COUNTY OF VENTURA PUBLIC WORKS AGENCY WATERSHED PROTECTION DISTRICT ZONE 2 "J" STREET DRAIN IMPROVEMENT ORMOND BEACH LAGOON TO DOWNSTREAM OF HUENEME ROAD IN THE CITY OF OXNARD

SAVE DATE: 5/21/13 DOKTORN K:\PC\PROJECTS\82322 J STREET DRAIN IMPROVEMENT\FINAL DESIGN\DESIGN DRAWINGS\100%ADDENDA\ADDENDUM NO. 1\JSD-01-GP.DWG

"J" STREET DRAIN IMPROVEMENT
ORMOND BEACH LAGOON TO
DOWNSTREAM OF HUENEME ROAD
GENERAL PLAN

SHEET 2
OF 31
DRAWING NO.
Y-2-3706

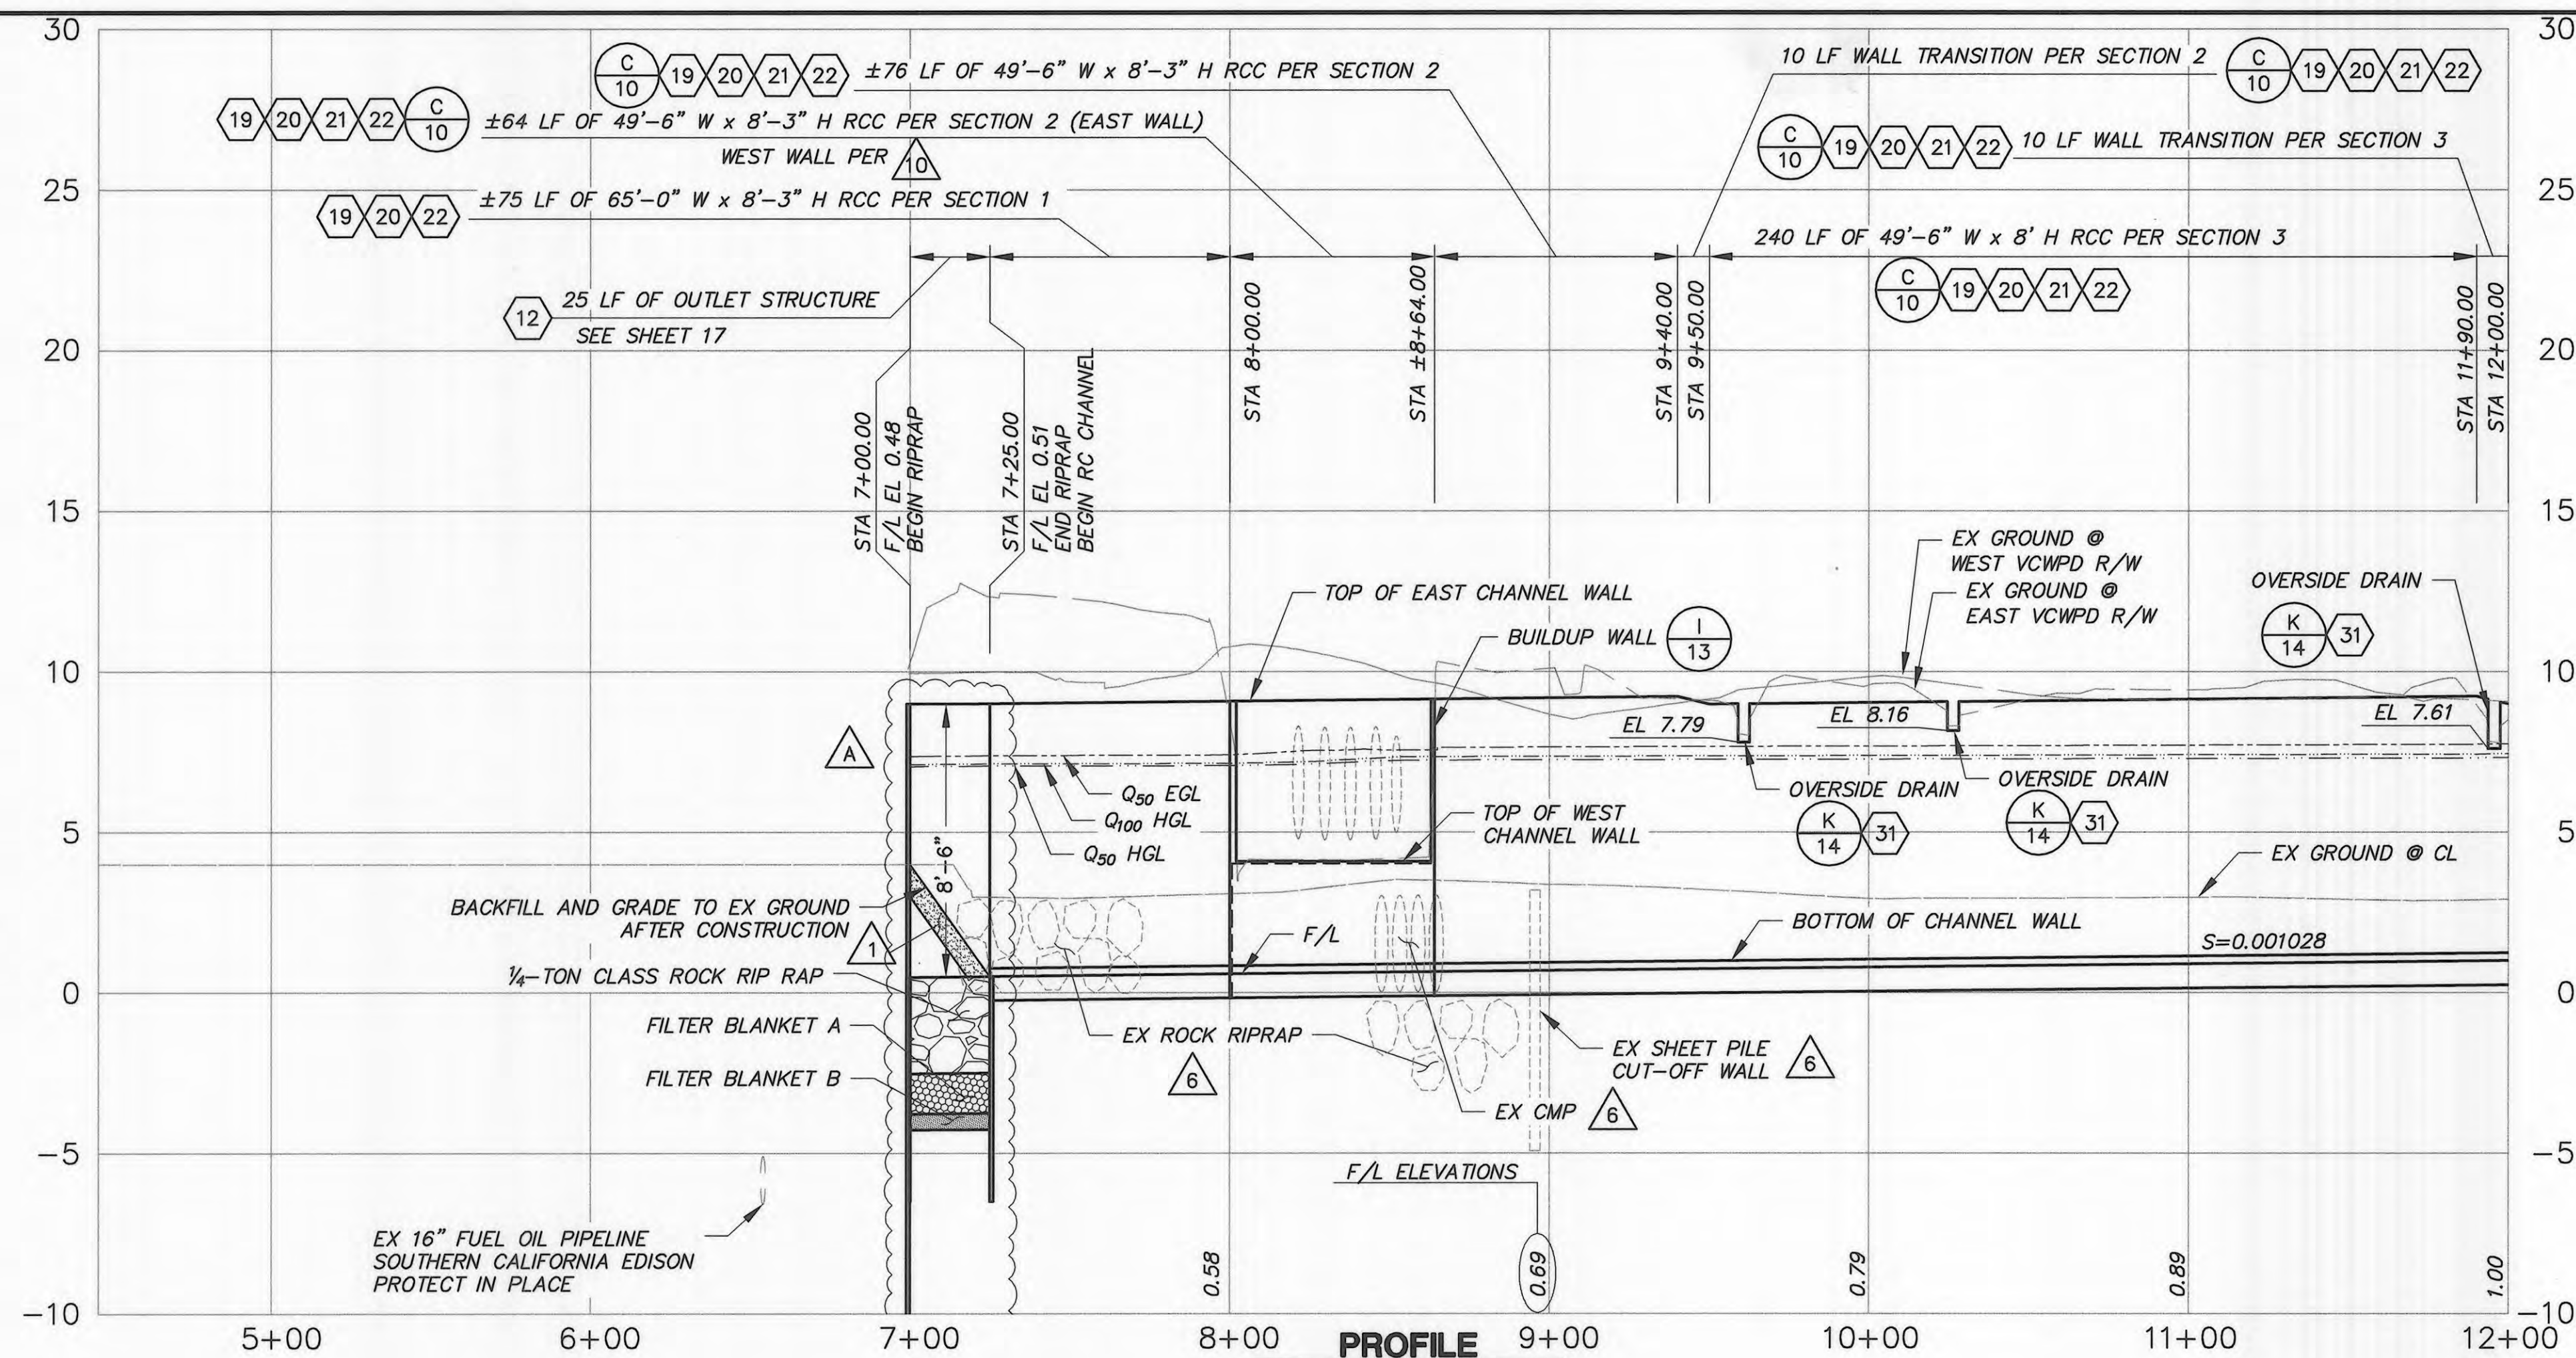
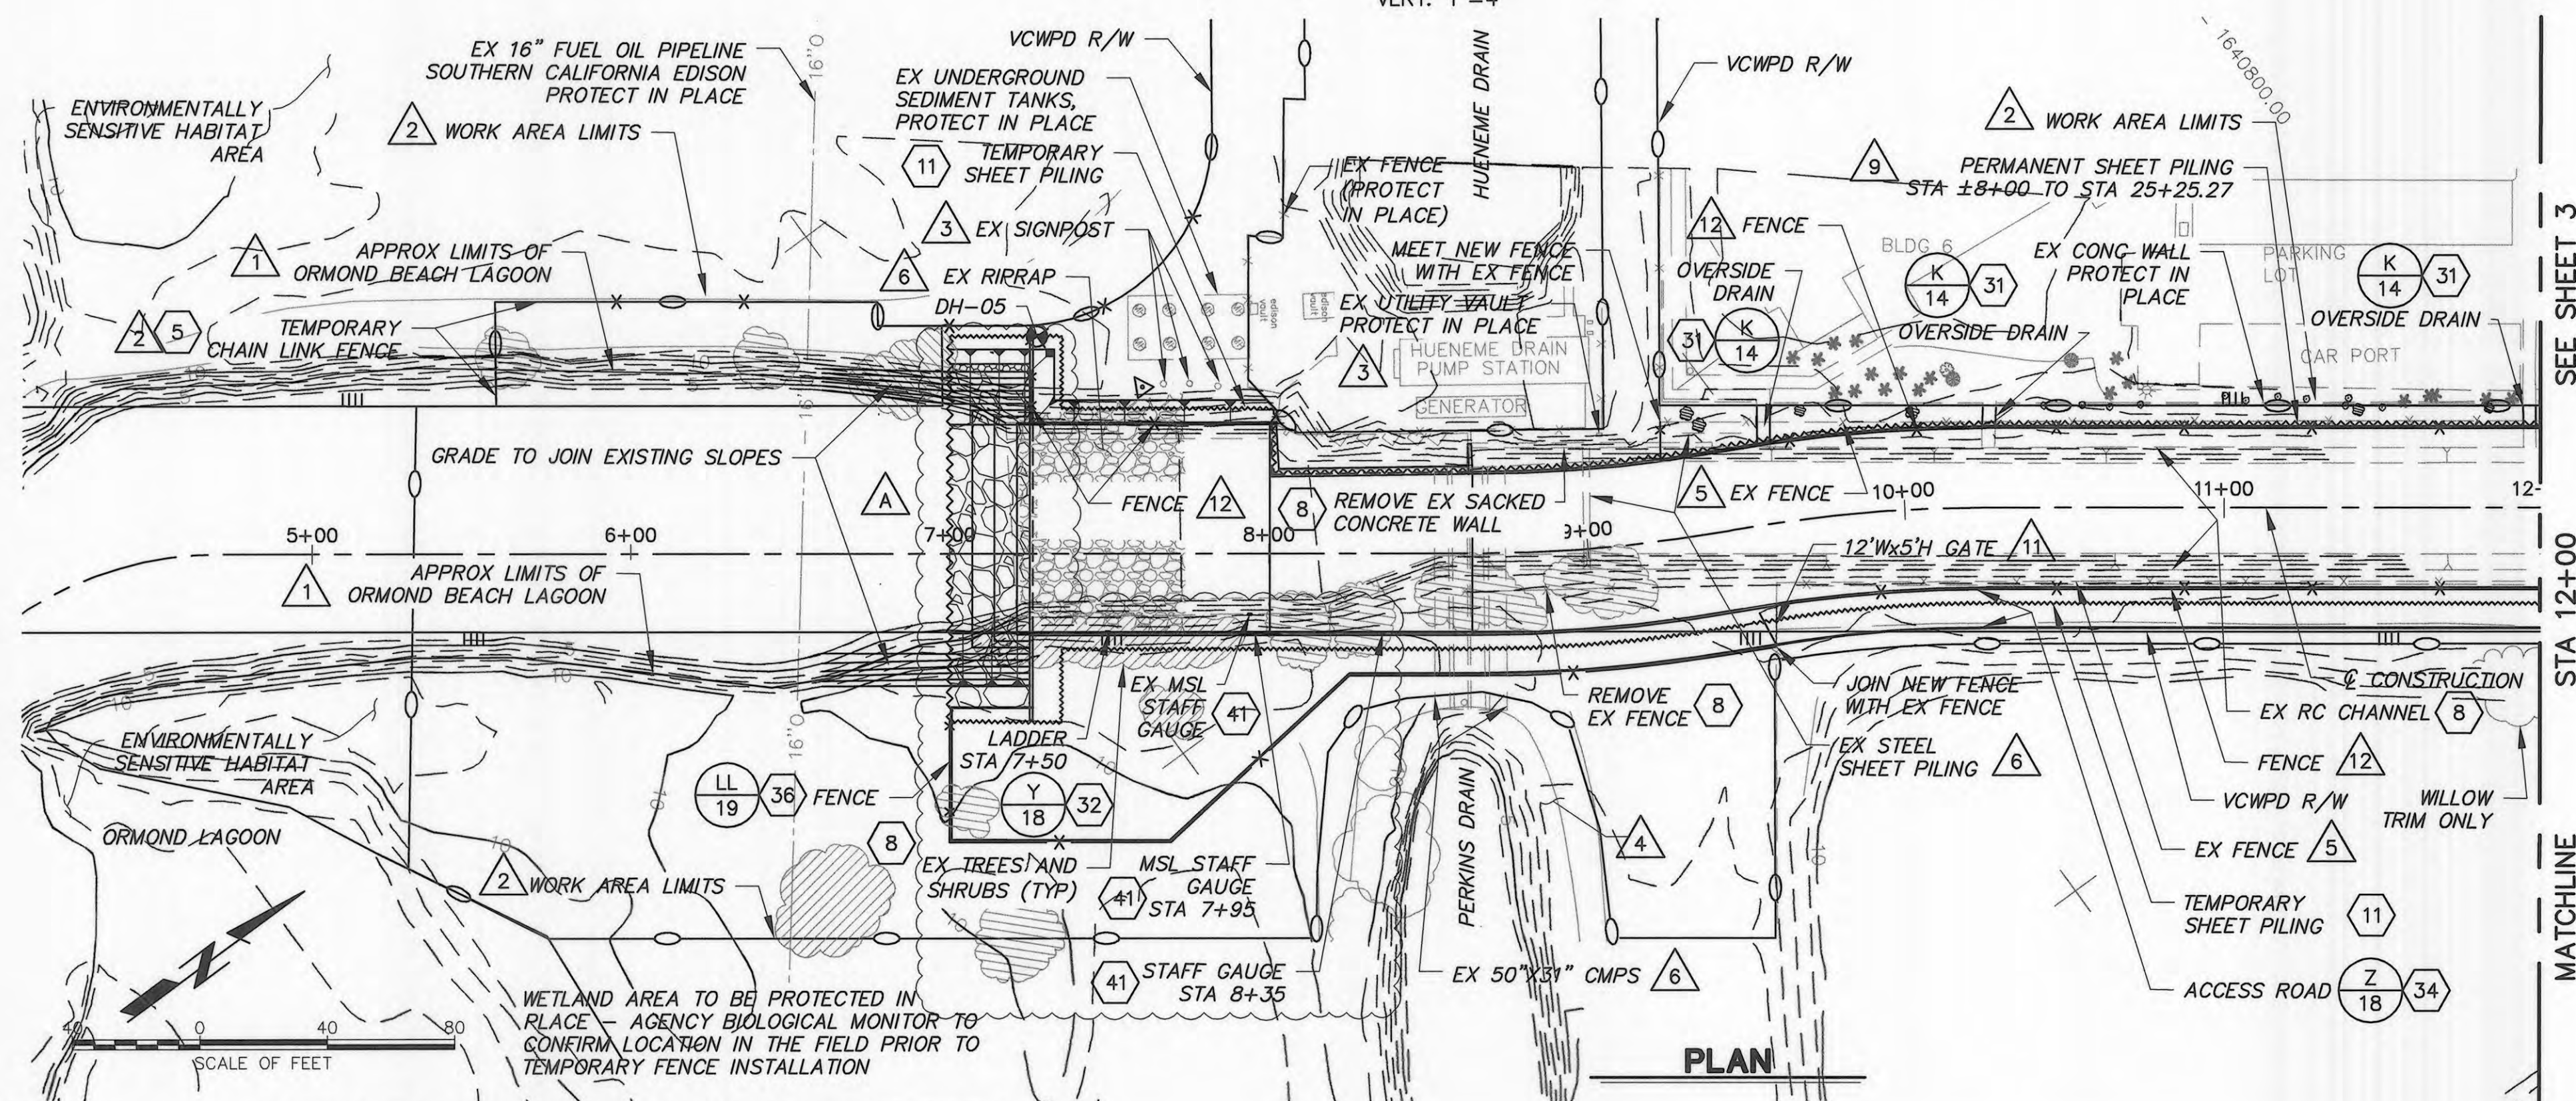
D					
C					
B	ADDED NOTE 12				
A	REVISED OUTLET STRUCT AND STAFF GAUGE				
Δ	REVISION DESCRIPTION	APP.	DATE
